PowerStream Inc.

EB-2015-0003

OEB Staff Compendium

November 23, 2015

Figure 44.1

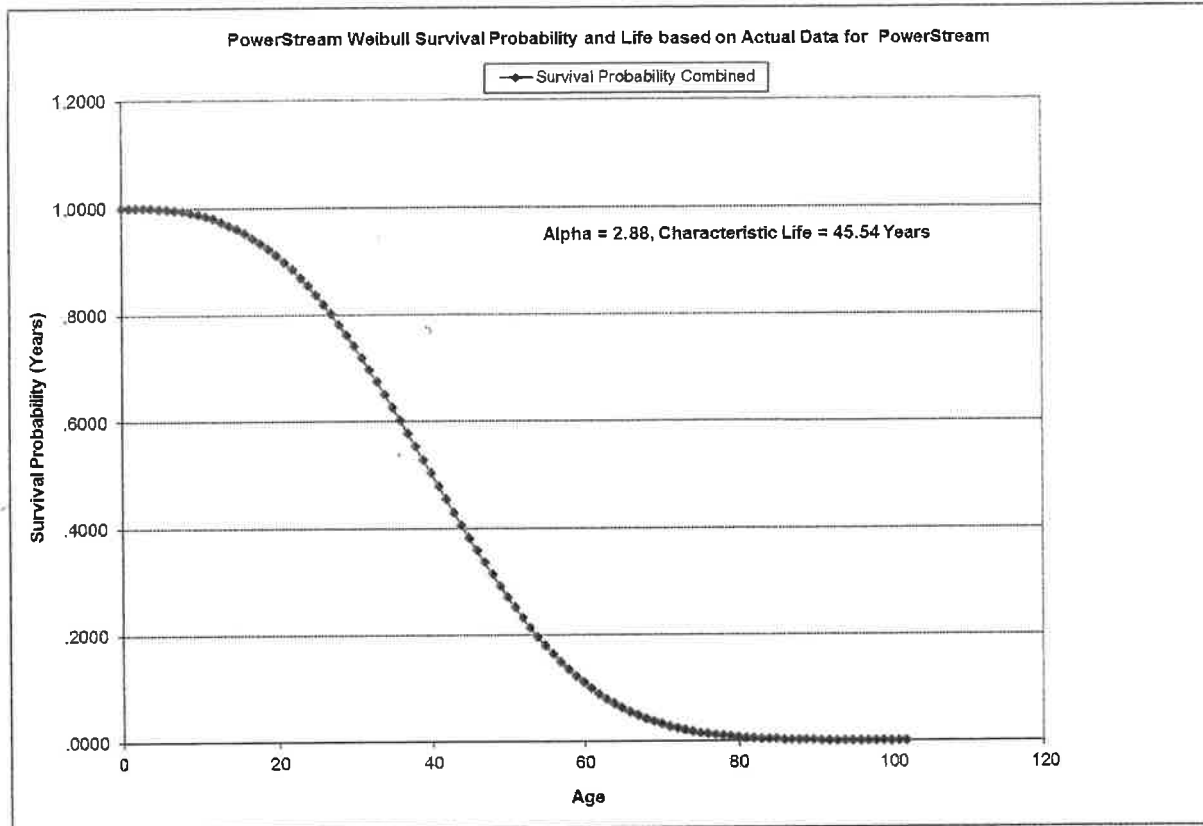
5
 6 Please state whether or not statistical analysis has been done to determine actual useful life of
 7 asset classes used by PowerStream. If yes, please provide this analysis.

10 All of PowerStream's assets are modelled based on Weibull Distribution. As with any statistical
 11 analysis and modelling it requires an adequate sample size for the analysis to be accurate and
 12 reliable. For many assets PowerStream does not have adequate failure numbers to be able to run
 13 Weibull analysis. PowerStream has completed the Weibull Analysis for the Poles and Switchgears
 14 and the results are shown in Table 44.1 & 44.2 and Figure 44.1 & 44.2 below.

Figure 5: Capital Budget Cycle

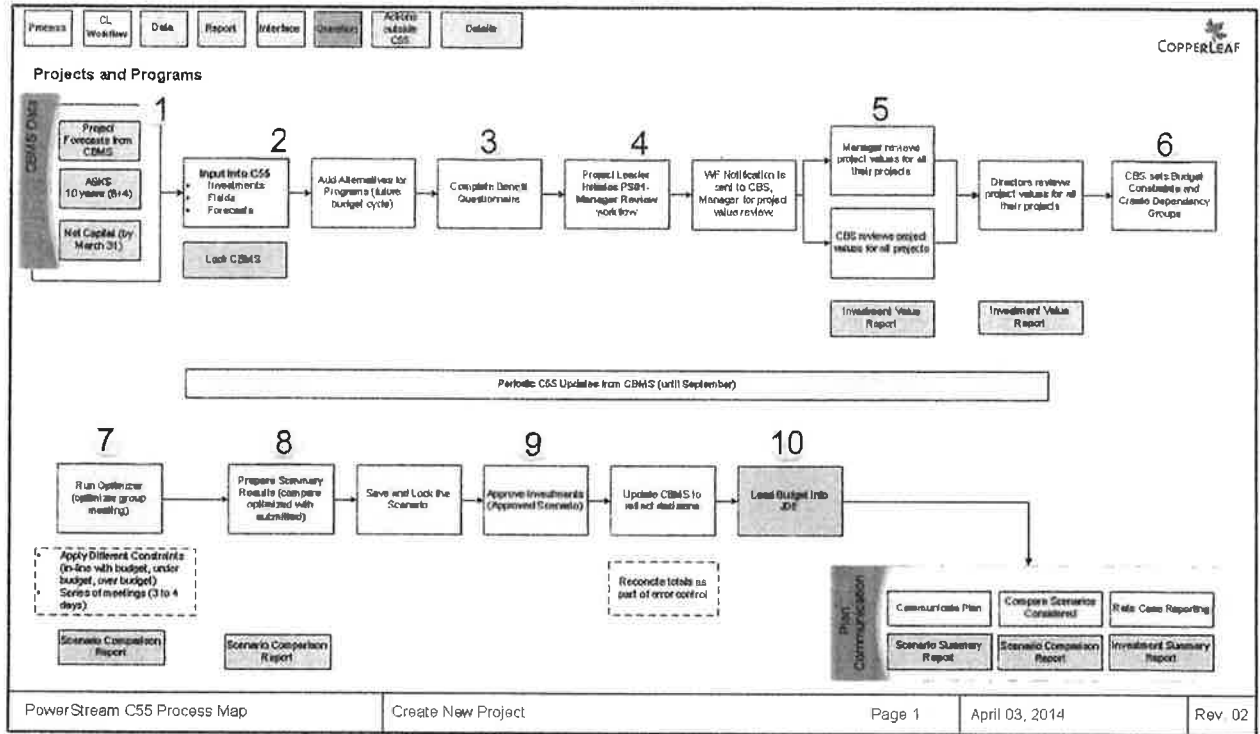
15 a) Please provide the Value Function of the optimization tool with a complete set of
16 parameters and weightings.

17 b) What is an objective function of the Value in the optimization tool? Please provide a
18 formula, whether an objective is to minimize or maximize.

19 c) In addition to the objective function in part b) please provide inequality and equality
20 constraints used to optimize the Value. Please describe how these constraints are being
21 set?

33 i) Please provide the Investment Value Report and Scenario Comparison Report (shown on
34 the Figure 5) from the C55 system for the run that was used to optimize DSP
35 programs/projects for 2015-2020:

- 8 e) Refer to Appendix Staff 51e, Full Project Listing Prior to Optimization.
- 9 f) The capital budget targets were filed as a response C-CCC-22 and can be found in Section
10 III, Tab 1, Sch 1, pg. 47. No other additional constraints were set. The constraint values
11 can be referenced in G-AMPCO-7(f) submitted in the previous interrogatories.

**Circuit Breaker
 Replacement Program**

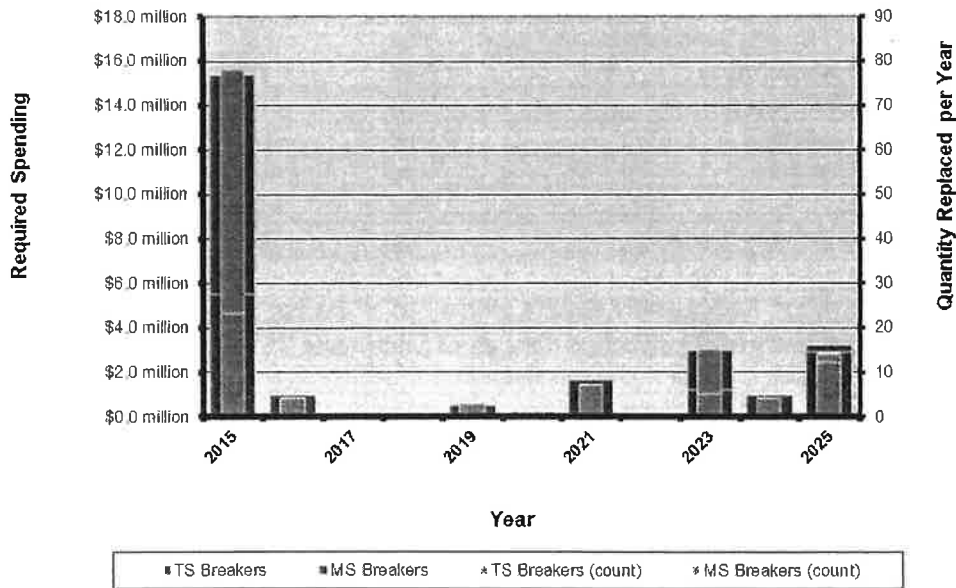
- 28 d) Did PowerStream update Risk-based economic analysis and Econometric replacement
29 results in accordance with the ACA report provided in EB-2013-0166? If yes, please
30 provide the results. If no, please explain.

**MS Primary Switch
 Replacement Program**

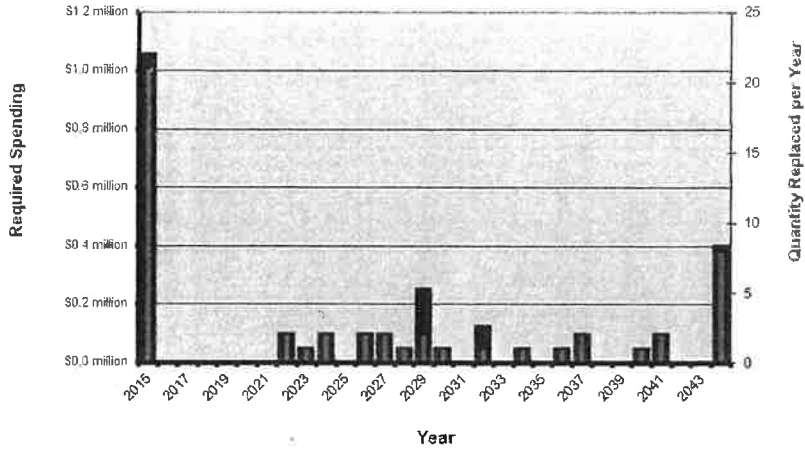
MR. HJARTARSON: The second part of that, can you provide the rationale for not including the replacement of MS primary switches and capacitor banks in the renewal program as indicated by the econometric replacement results for these parts in the answer, or are they maybe perhaps hidden somewhere else?
